Access Compliance Report

Public Rights-of-Way

Intersection ID: 18584	Main Street: NOTTINGHAM_DR	Cross Street: ROBINHOOD_RD	Location:	W
ADA ID: 4EA5437D65AB	Ramp Type: BlendTrans1	Initial Pass/Fail: Fail	Overall Compliance: No	Severity Score: 10

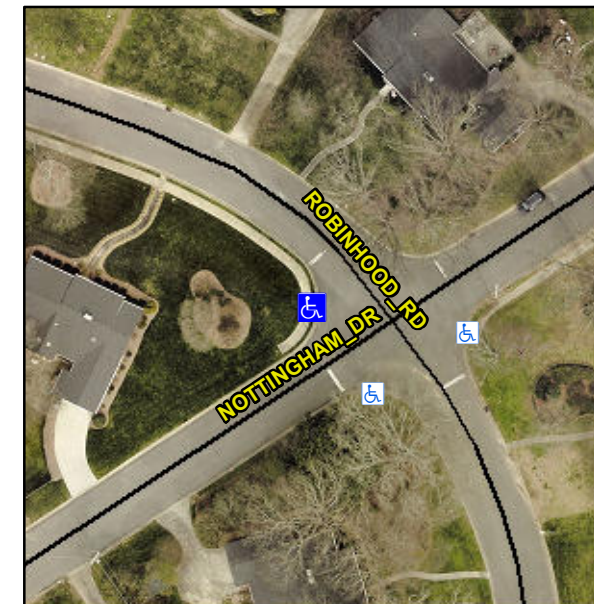
Not Found, R304.5.1, R304.5.3

Compliance	Description	Data	Compliance	Description	Data
N/A	Ramp Length (in)	28.0	Yes	BlendTrans Slope (%)	2.5
No	Ramp Width (in)	44.0	No	BlendTrans XSlope (%)	4.0
N/A	Flare Type LT	N/A	N/A	Flare Type RT	N/A
N/A	Flare Slope LT (%)	N/A	N/A	Flare Slope RT (%)	N/A
N/A	Flare Traversable LT?	N/A	N/A	Flare Traversable RT?	N/A
N/A	Landing Length (in)	N/A	N/A	DWS Provided?	N/A
N/A	Landing Width (in)	N/A	N/A	DWS Contrast?	N/A
N/A	Landing Slope (%)	N/A	N/A	DWS Length (in)	N/A
N/A	Landing X Slope (%)	N/A	N/A	DWS Full Width?	N/A
N/A	Landing Curb? (Y/N)	N/A	N/A	DWS Offset (in)	N/A
N/A	Shared Landing?	N/A			
N/A	Gutter Ponding?	N/A	N/A	Gutter Slope (%)	N/A
N/A	Gutter Lip Ht (in)	N/A	N/A	Gutter X Slope (%)	N/A
N/A	Painted X Walk1?	No	N/A	Painted X Walk2?	No
	X Walk 1 Direction	To SE		X Walk 2 Direction	To NE
	X Walk 1 Width (in)	N/A		X Walk 2 Width (in)	N/A
	X Walk 1 Slope (%)	6.8		X Walk 2 Slope (%)	2.5
	X Walk 1 X Slope (%)	1.1		X Walk 2 X Slope (%)	7.1

N/A	Ramp inside XWalk1?	N/A	N/A	Ramp inside XWalk2?	N/A
	Road Slope (%)	5.3		Clear Space?	N/A
	Road X Slope (%)	5.9	N/A	Clear Space to XWalk (in)	N/A
N/A	Any Obstructions?	N/A	N/A	Storm Grate/Utility Hazard?	N/A
	Obstruction Type			Storm Grate/Utility Type	
		N/A			N/A
			Yes	Surface Condition? (G/P)	Good
			No	Curb Slope (%)	10.1

Remove & Replace Curb Ramp With Two New Directional Ramps or Equivalent.
